ZONING BOARD OF APPEALS MEETING
LOCATION: TOWNSHIP ANNEX, 7527 HIGHLAND ROAD, WHITE LAKE, MICHIGAN 48383
THURSDAY, APRIL 24, 2025 – 6:30 PM

AGENDA

TO: Zoning Board of Appeals
FROM: Andrew Littman, Staff Planner
DATE: April 14, 2025

PRELIMINARY/FINAL SITE PLANS FOR:
WHITE LAKE MOTORS
MICHIGAN AUTOMOTIVE GROUP
CHARTER TOWNSHIP OF WHITE LAKE, OAKLAND COUNTY, MICHIGAN

SHEET NUMBER
A-2

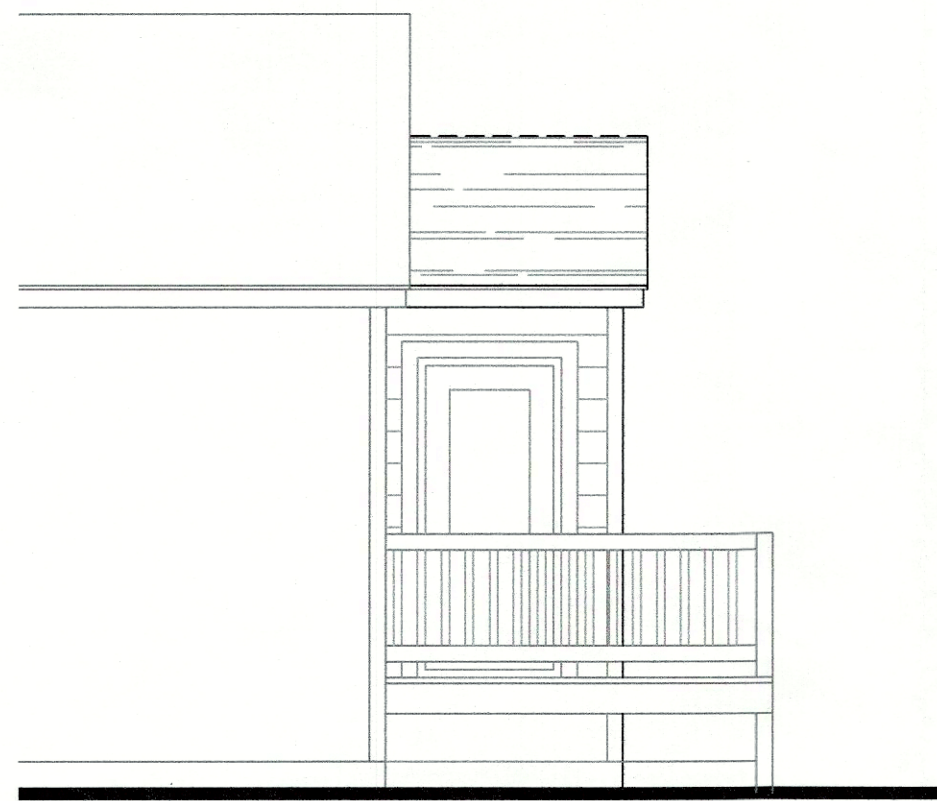
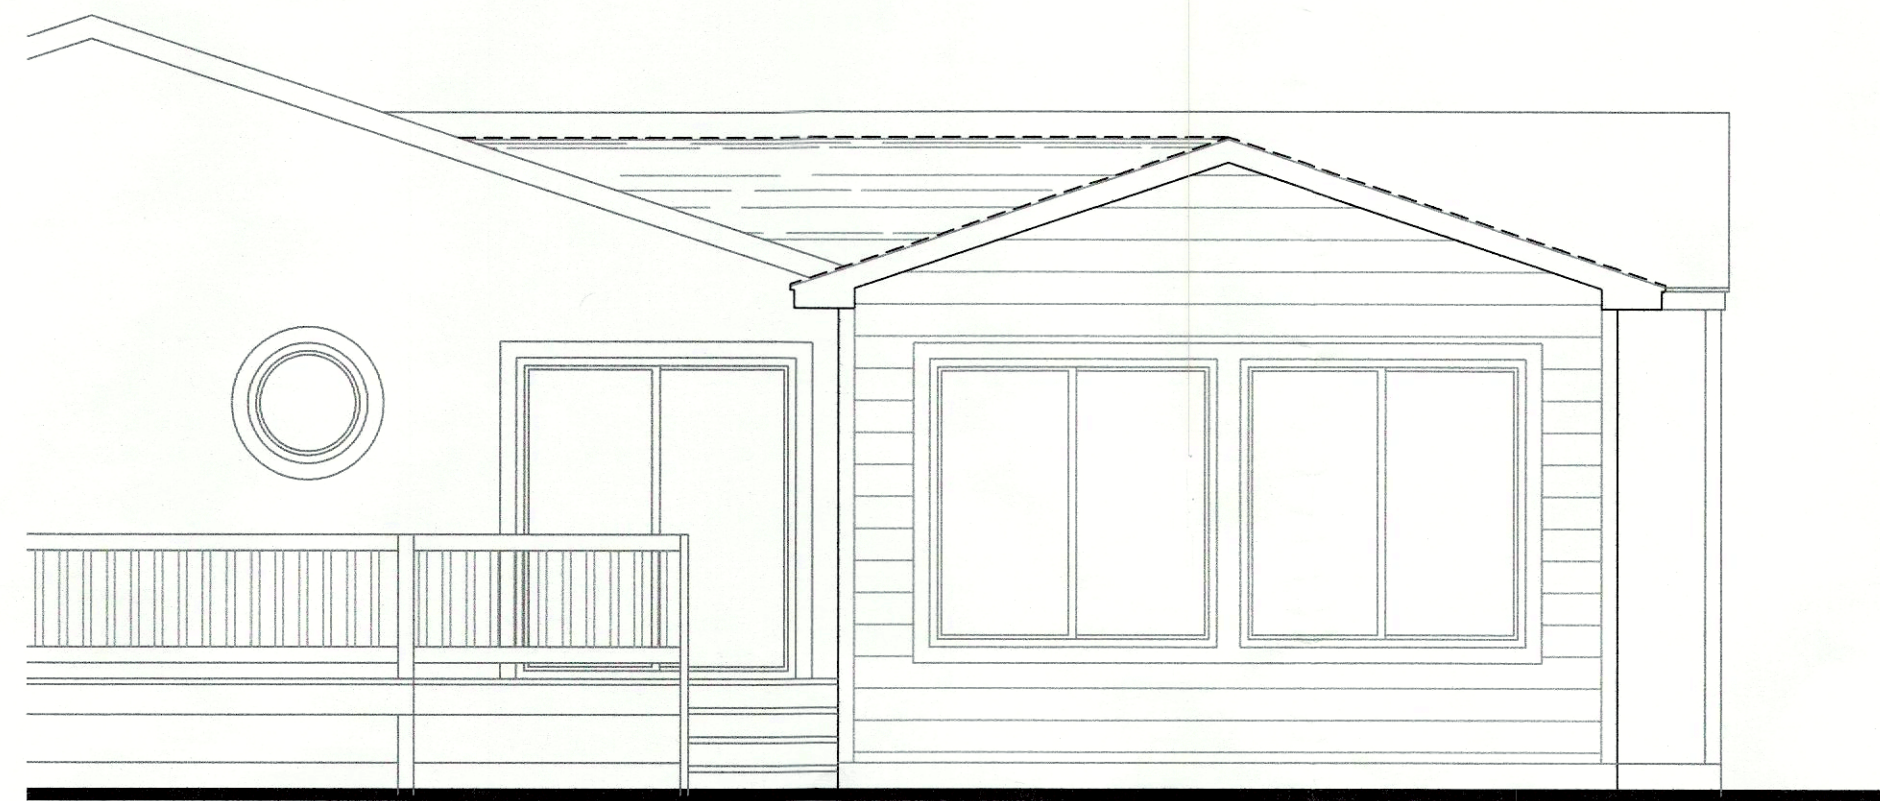
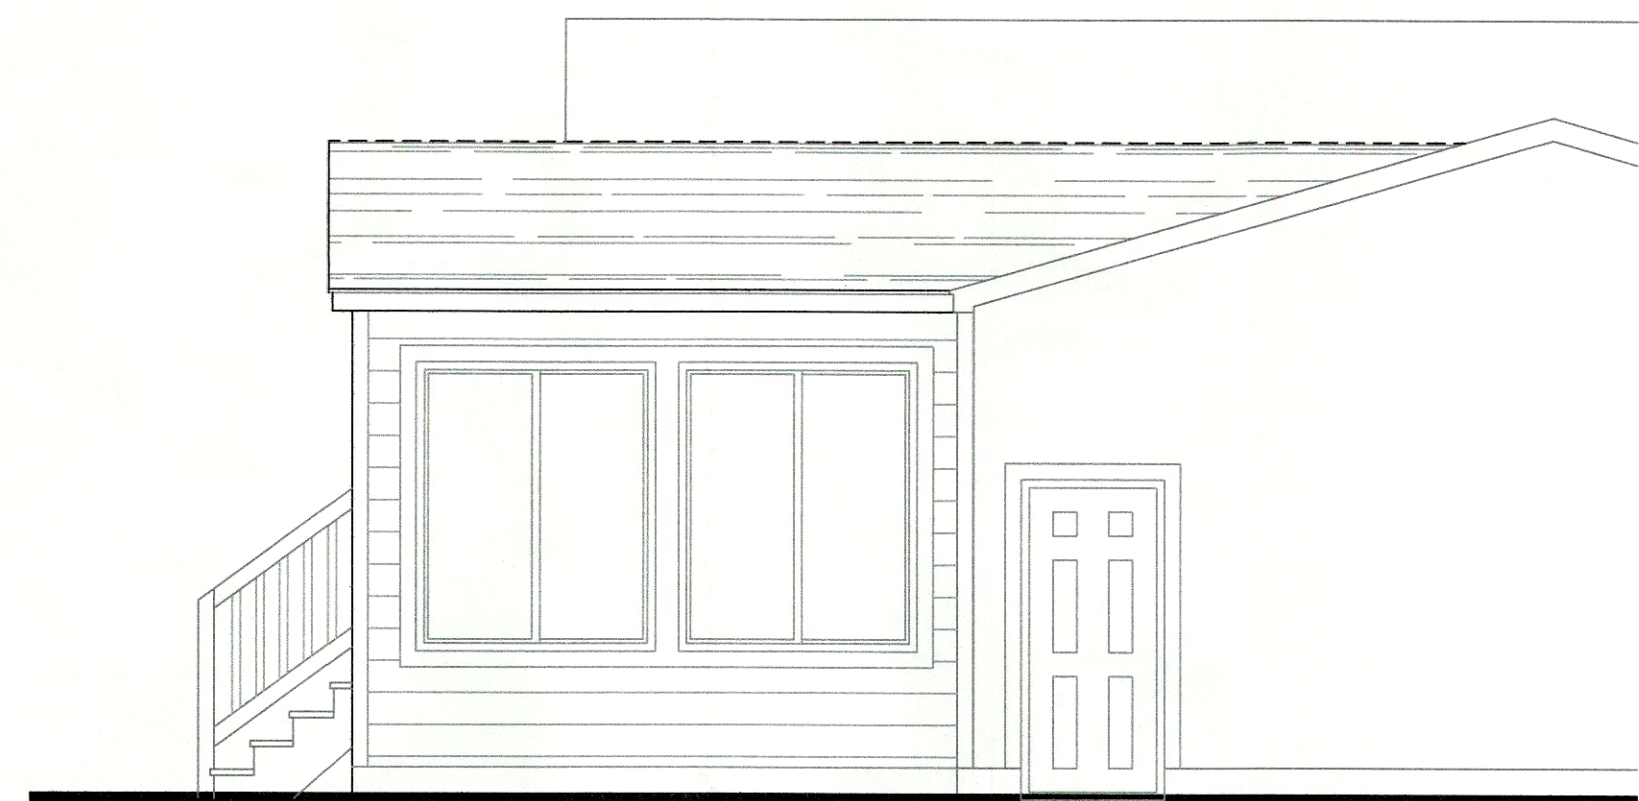
The Applicant's proposed four-seasons room (which would be added onto the back of the home) would come 5.4 feet from the east side yard lot line, requiring a 4.6-foot side yard setback variance.

3. No mechanical units, including HVAC system or generator, shall be placed closer than five feet to any side yard lot line
4. An as-built survey shall be required to verify the approved setbacks

SHEET
C-2

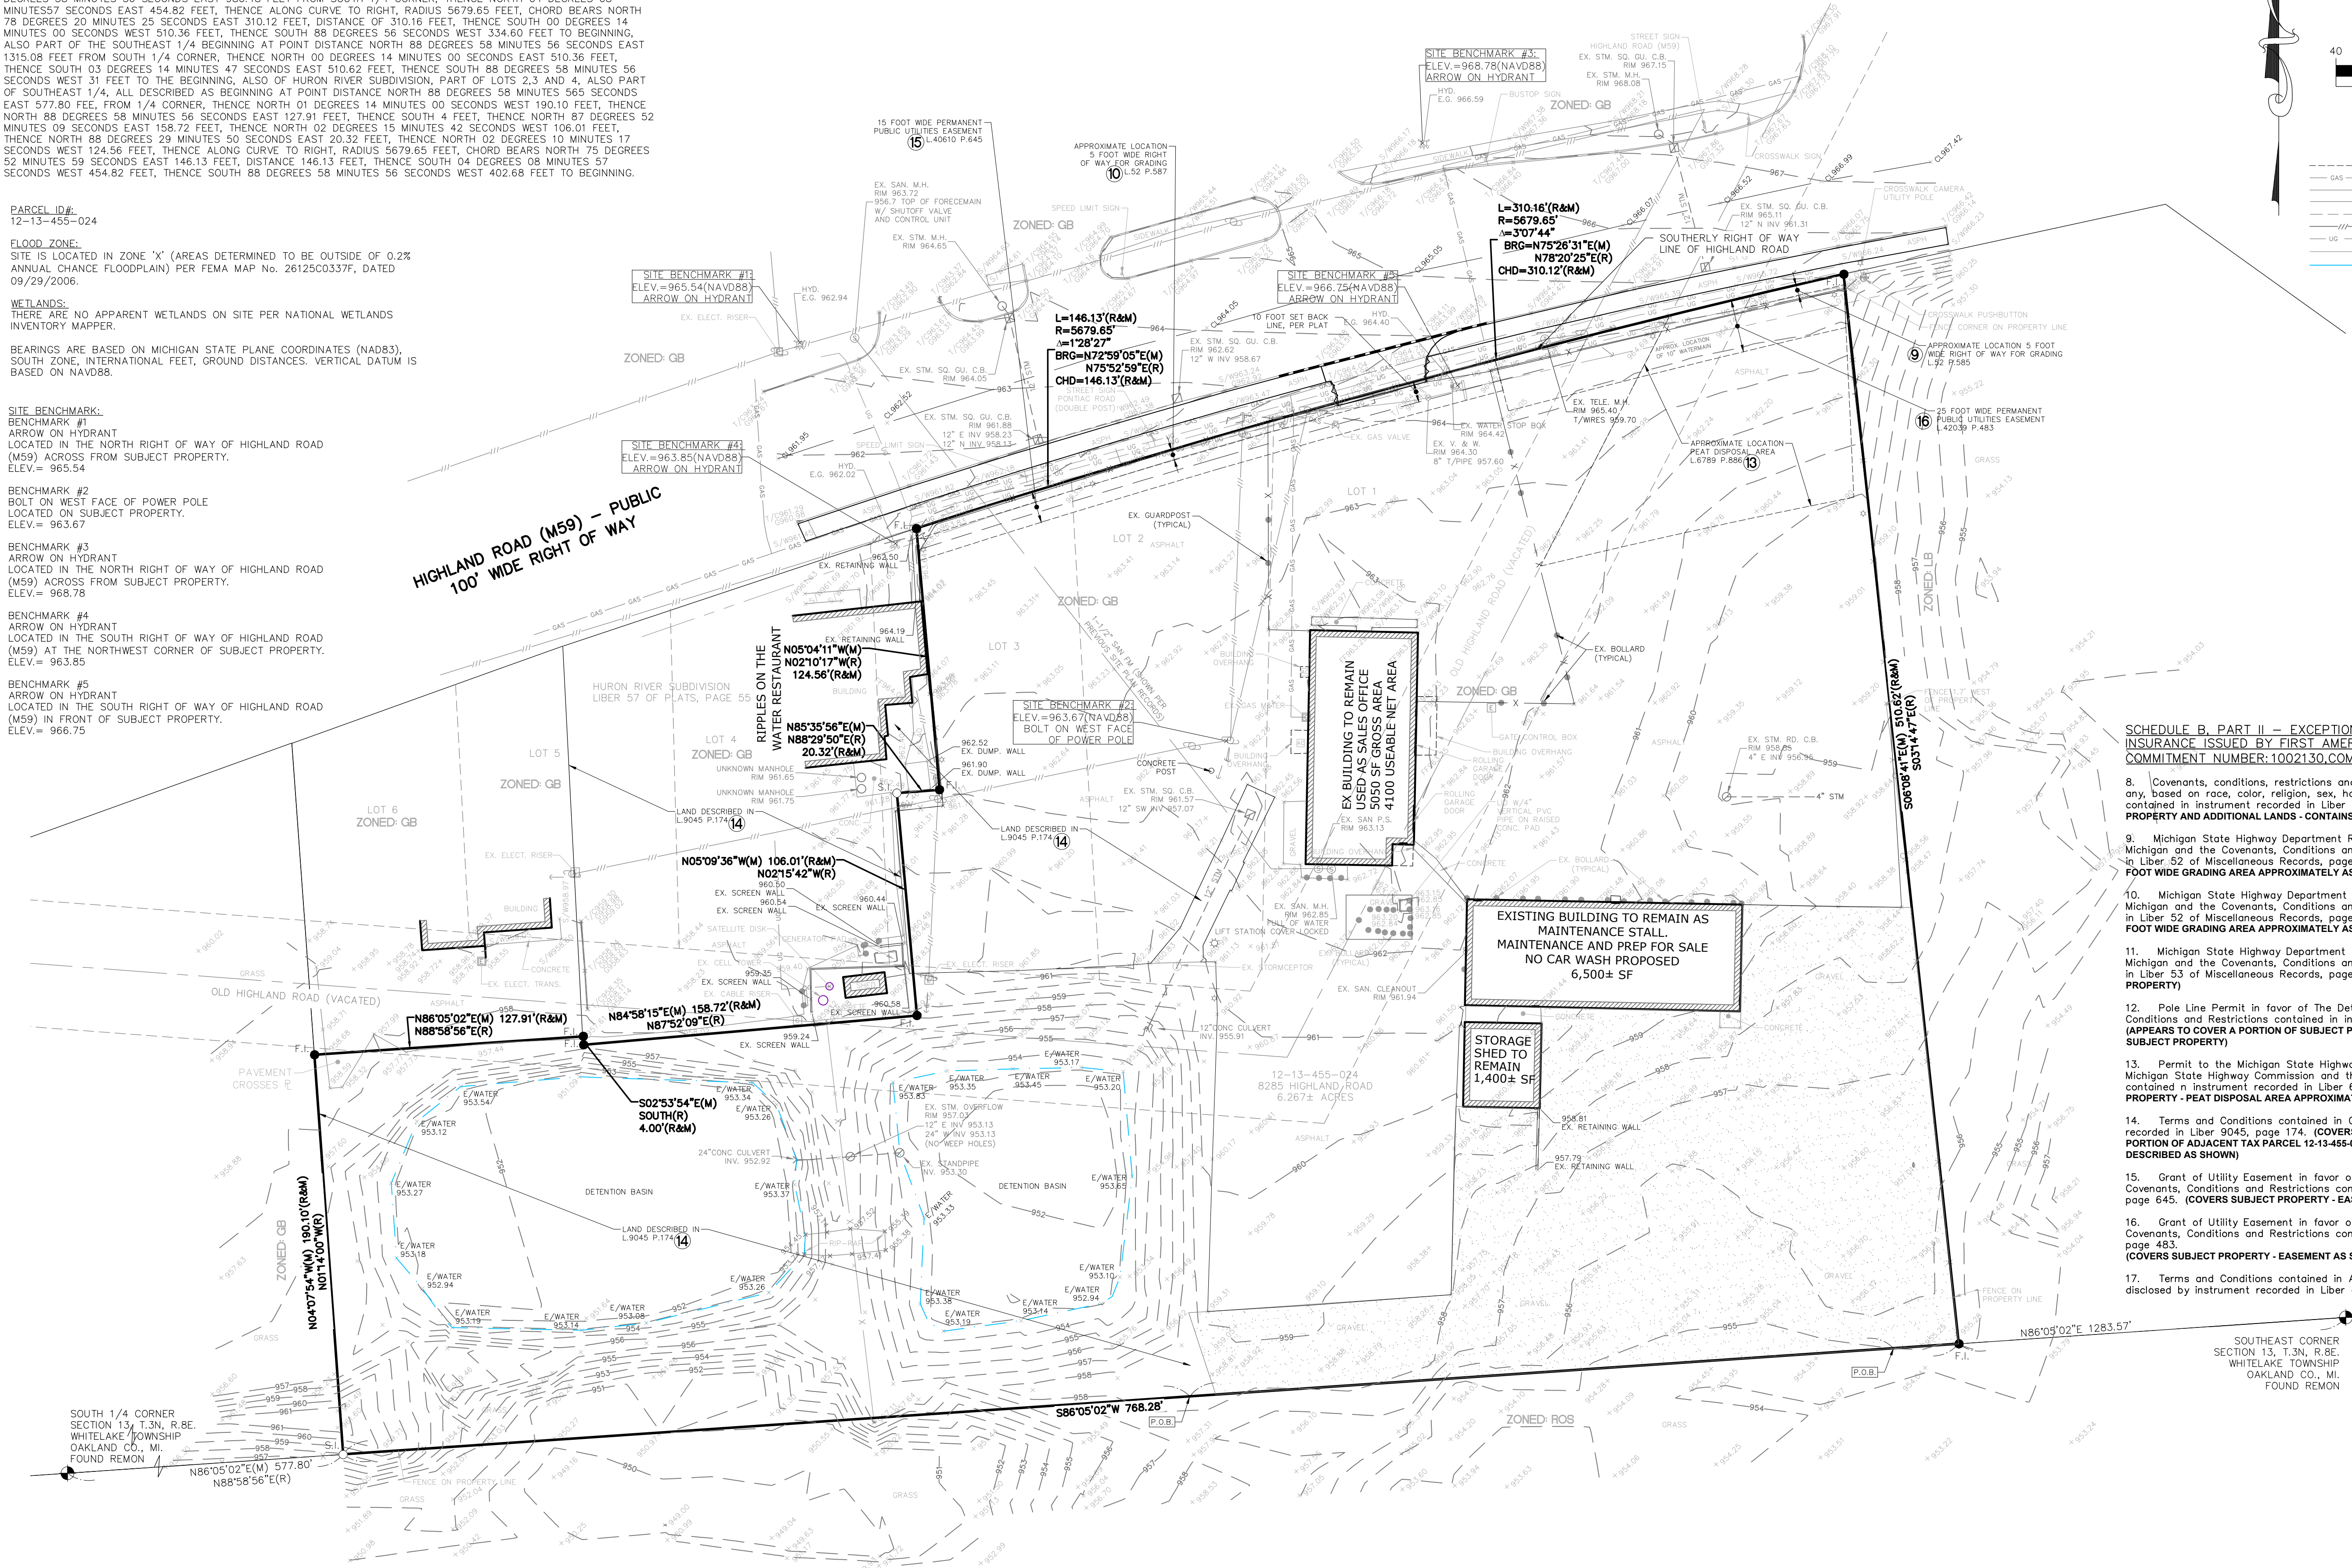
Topography:	Sheet C-2 and C-5 show existing site topography as well as the proposed grading. Much of the site is relatively level given the prior use.
Wetlands:	Sheet C-2 states "There are no apparent wetlands on site per national wetlands inventory mapper". A wetland survey is provided via the National Wetland Inventory service. Wetlands abut the site along the east, south, and west property lines.
Woodland:	The site is relatively clear of mature tree clusters per prior uses. Mature trees and vegetation are located near the existing detention basins in the site's southwest corner.
Soils:	Oshtemo-boyer loamy sands and Houghton and Adrian mucks are present on the site.
Water:	No natural bodies of water are onsite. Sheet C-2 states the site is located in Zone "X" (areas determined to be outside of 0.2% annual change floodplain) per FEMA map No. 26125CO337F, dated 09/29/2006.
General Notes:	None.
